ECE/TRANS/WP.30/GE.1/2007/8  
7 May 2007

Informal Ad hoc Expert Group on the Conceptual and  
Technical Aspects of Computerization of the TIR Procedure

World Customs Organization transit data model

Proposed data modification requests (DMRs)

Annex 2  
WCO transit data model version 3  
(English only)

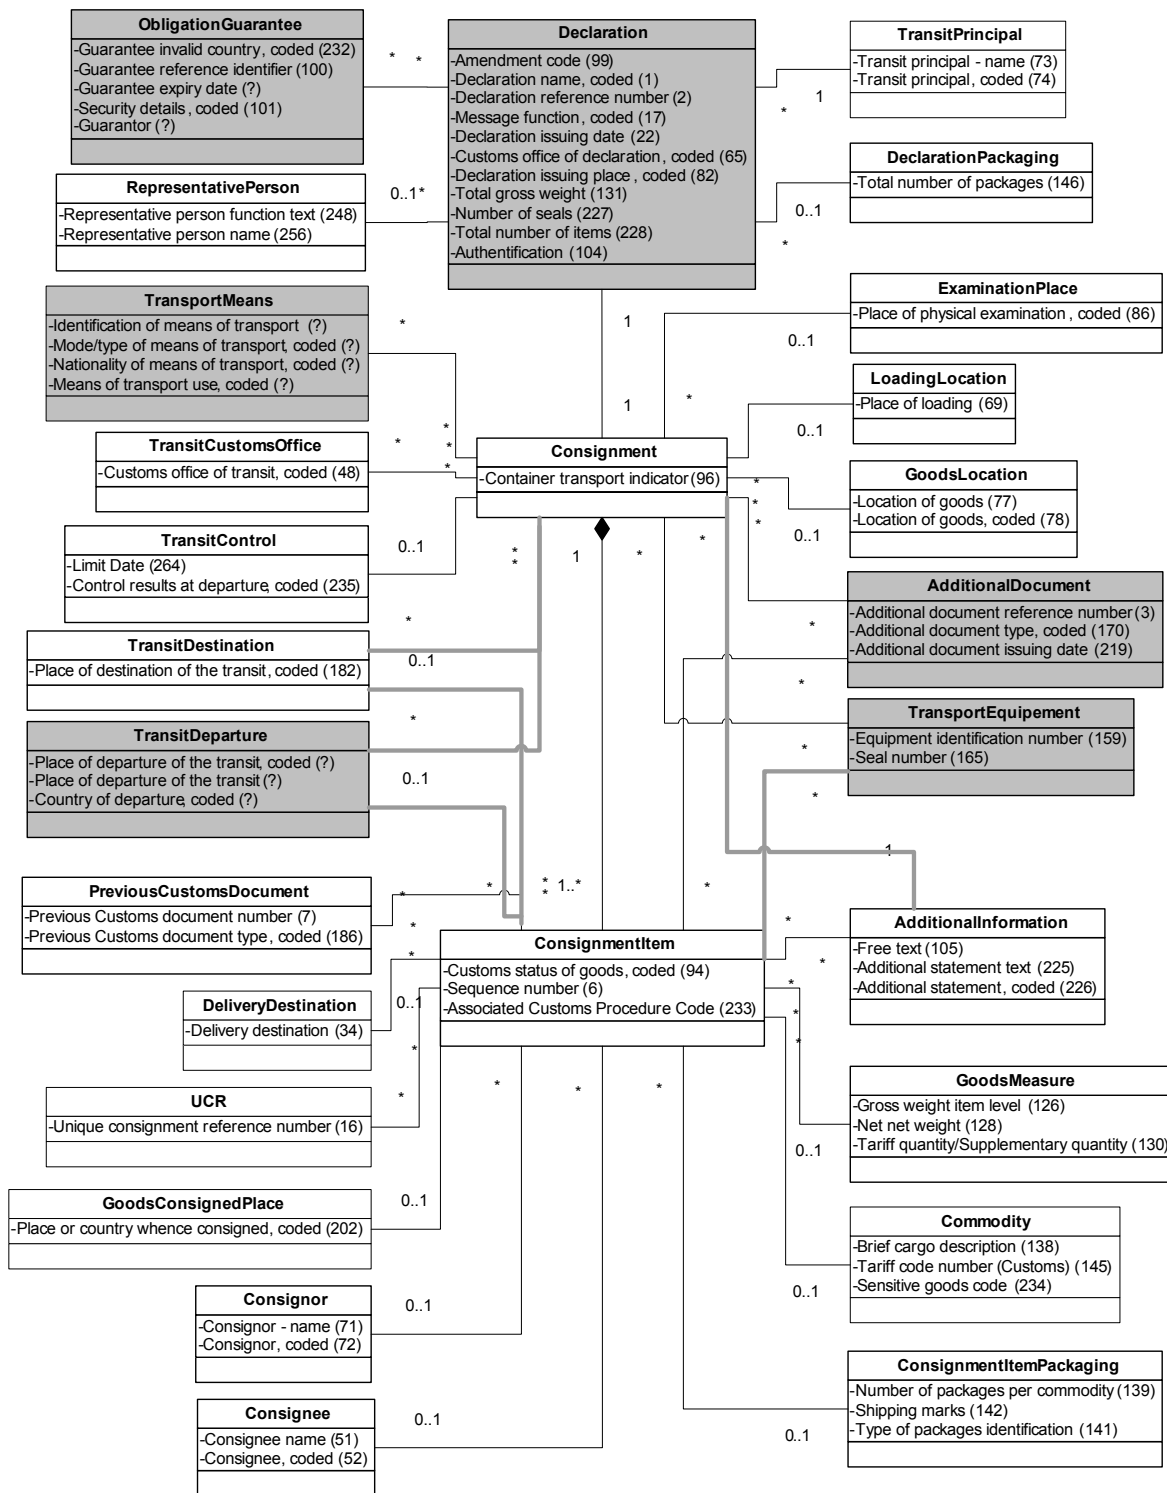
5. The Expert Group may wish to advise the secretariat on the proposed modifications to the WCO transit data model and react to the comments provided by the secretariat. Annexes 1 and 2 show respectively how the data elements list would be affected by the proposed changes and how the data model would look like.
